Authorized Field Change

AFC 08903R2

Subject: VT 275 and MaxxForce 5 Case to Head Tube and Plug D-Ring Seal Deterioration

Model: CF 500

Figure 11 Removing the crankcase-to-head plug (with check valve)

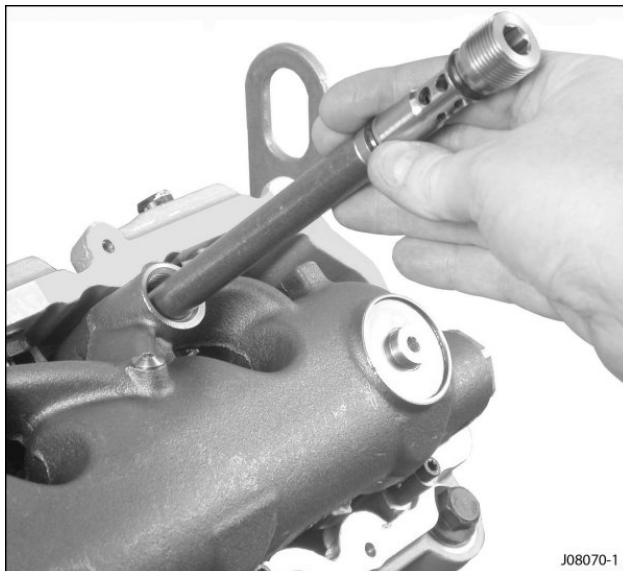
Step 4 after Figure 11 has been revised.

11. Lift out the crankcase-to-head tube assembly and discard.
